UNITED STATES PATENT AND TRADEMARK OFFICE

Office Action Summary

10/655,590

DRAKE, PETER ANTHONY

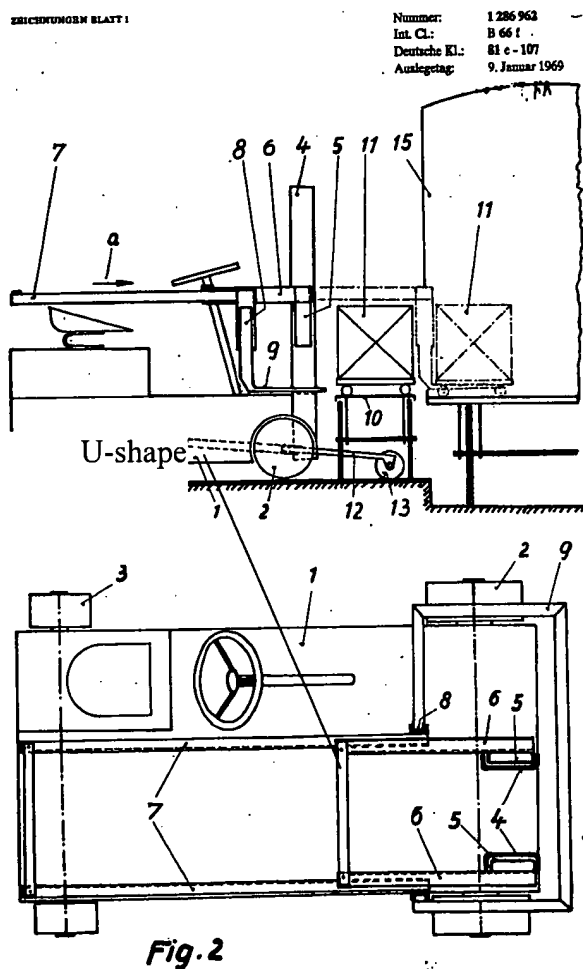
The cited prior art includes a U-shape (see FIG. 2 below), and with respect to “only three wheels”, Applicant’s invention is not limited to a particular number because the preamble does not include the language “consisting of” which would preclude any additional structure beyond that of Applicant’s. Further, arguments that the cited prior art does not have the “lifting capability” of Applicant’s is unclear because it doesn’t recite
